APPLICATION NO.	FILING DATE	FIRST NAMED INVENTOR	ATTORNEY DOCKET NO.	CONFIRMATION NO.
10/786,139	02/26/2004	Christopher J. Wanner	NVL 3289	3482

**Advisory Action  
Before the Filing of an Appeal Brief**

TITLE: MINE SIFTING ATTACHMENT HAVING TRANSVERSE BLADES  
INVENTOR: CHRISTOPHER J. WANNER  
APPLICATION SERIAL NO. 10/788,139  
DOCKET NO. NVL 3289

Fig. 2

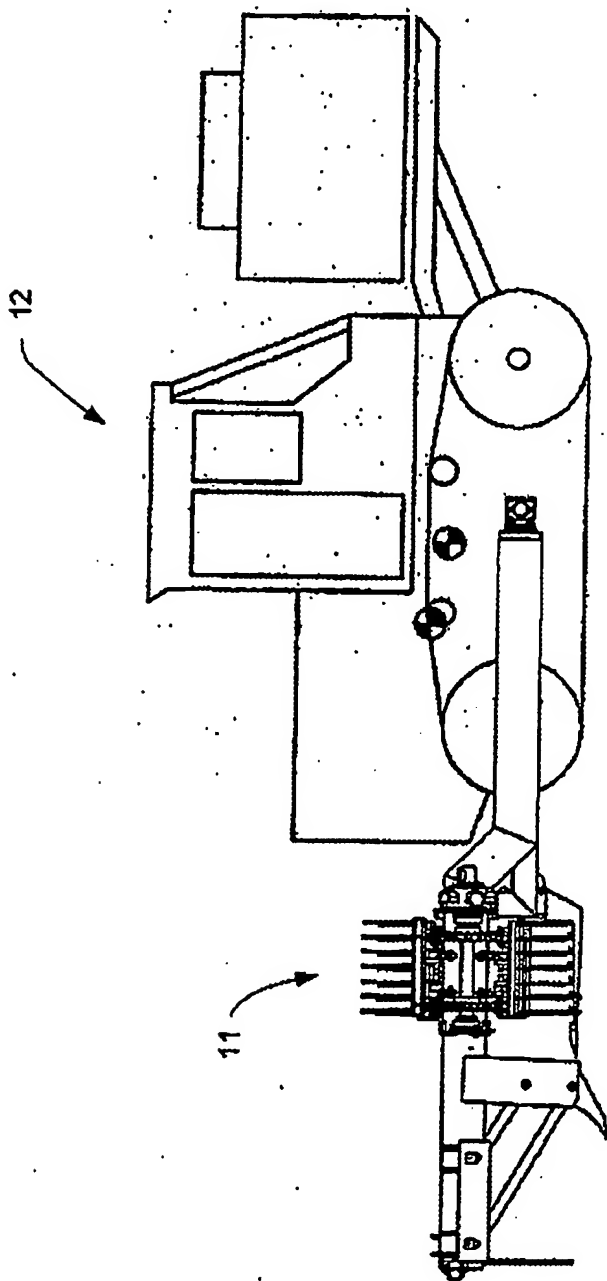
Continuation of 3. NOTE: Proposed Fig. 2 raises the issue of new matter because applicant has provided details on the tractor that do not have basis in the original disclosure. The examiner suggests submitting a different Fig. 2 that does not include specific tractor details. The examiner suggests representing the tractor with a box diagram, with the minesweeper attached, and with the front and/or rear of the tractor as well as the direction of travel indicated. The proposed changes to the claims and specification would have been acceptable if not for the drawing issues.
